Manual 12 Updates

Danielle Martini
Engineer - Performance Compliance
February 24, 2015

Exhibit 12. Assigned Regulation and Regulation Range requirements

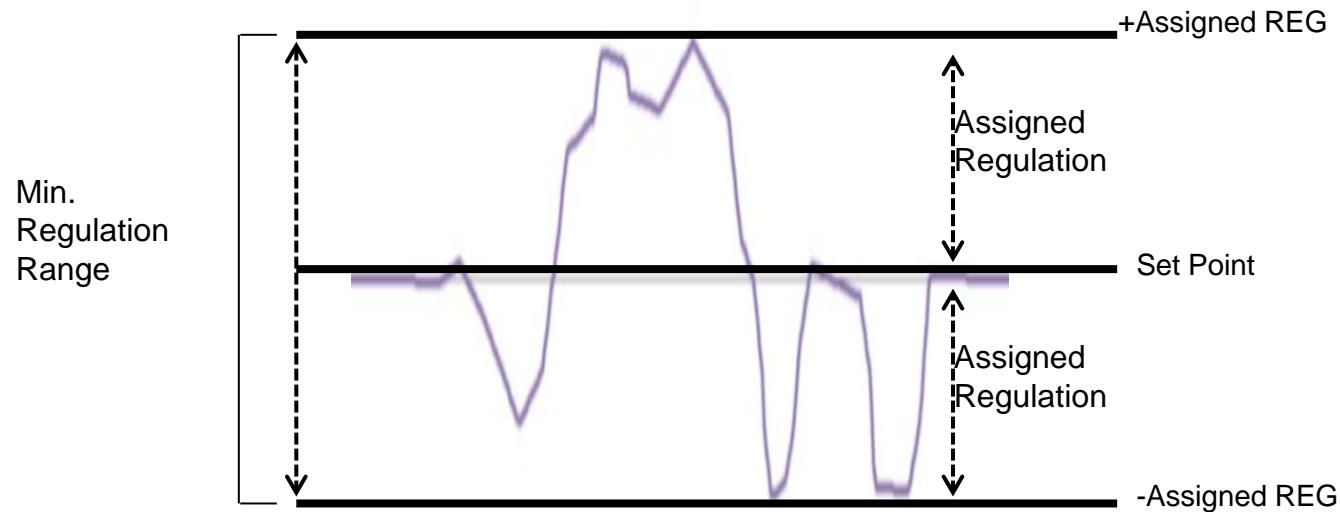
- Description of the regulation range and assigned regulation to state a resource is required to symmetrically provide the total amount of Regulation assigned
 - Regulation Range cannot allow a DSR to inject energy into the BES

The PJM RTO requires that the Regulation range of a resource is at least twice the amount of Regulation assigned, **and that the resource can symmetrically provide the total amount of Regulation assigned (a full raise and lower of assigned regulation from set-point) as illustrated in Exhibit 12 below.**
